Stage 02: Industry Consultation

National Electricity Transmission System Security and Quality of Supply Standards (NETS SQSS) and Grid Code

GSR018 / GC0077: Sub-Synchronous Oscillations (SSO)

01	Workgroup Report
02	Industry Consultation
03	Report to the Authority

Figure 1: Typical modal electrical undamping characteristics with examples of sufficient damping (point 'a' and point 'b') and insufficient damping (point 'c'). This figure is for illustrative purposes only and does not completely reflect the characteristics of any of the projects in progress.

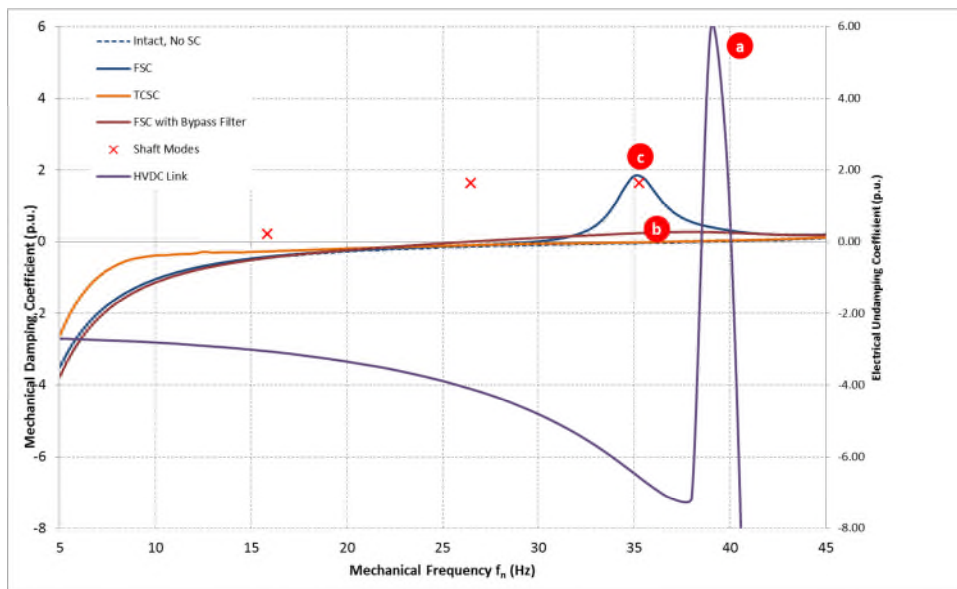
- 4.78 The definition for Unacceptable SSO should be such that it is required to be met at frequencies where there is a potential risk. It should also not rule out that positive electrical undamping may coincide with a modal mechanical frequency provided that the overall damping is positive. This is illustrated by point 'a' and point 'b' in Figure 1. However, it should prevent situations where the high positive electrical undamping coincides with a mechanical mode of low mechanical damping as illustrated by point 'c' in Figure 1.

Figure 2: Potential interactions between the proposal and CUSC Section 13.

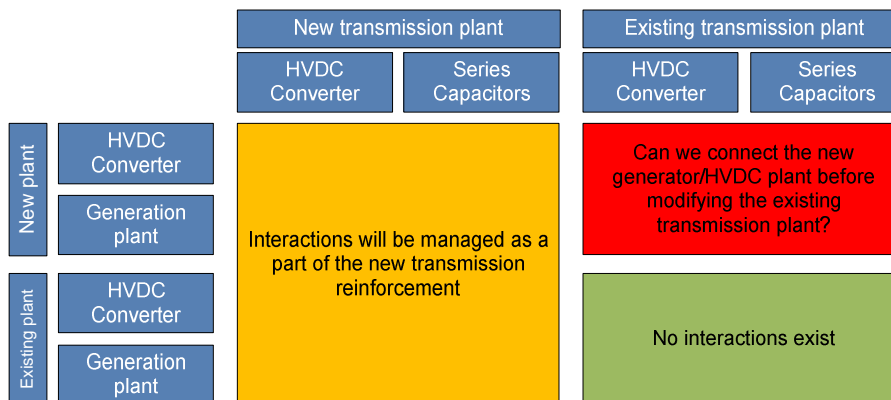
- 4.112 The Workgroup discussed the potential interactions between CUSC Section 13, Enabling Works and the NETS SQSS criteria proposed. The potential combinations of these interactions are summarised in Figure 2. There should be no Unacceptable SSO resulting from interactions between existing Transmission Plant and existing User Plant as these would have already been taken care of. Unacceptable SSO resulting from interactions between new Transmission Plant and Users' plant, whether the Users' plant is already connected or due to connect, will be addressed in line with the programme of the relevant transmission project. Where interactions between new Users' plant and existing transmission plant may result in Unacceptable SSO, these interactions will be assessed by Transmission Licensees who will need to identify the works required to meet the NETS SQSS criteria and then classify the works identified into either Enabling Works or Wider Transmission Reinforcement Works.

- 4.113 Transmission reinforcement works required to meet the NETS SQSS Section 2 pre-fault SSO criteria will be automatically classified as Enabling Works in line with Clause 13.2.4.1 of the CUSC, whereas works required to meet the NETS SQSS Section 2 post-fault criteria would need another qualifier if these were to be classified as Enabling Works. This additional qualifier could be that these works are required to enable NGET to operate the NETS in a safe manner (13.2.4.3), comply with the Grid Code criteria (13.2.4.5) or avoid any adverse impacts on other Users (13.2.4.7).
- 4.114 If a User were to connect to the system prior to the completion of all the works required to mitigate Unacceptable SSO, NGET would have to either switch the transmission plant interacting with the User's plant permanently out of service or
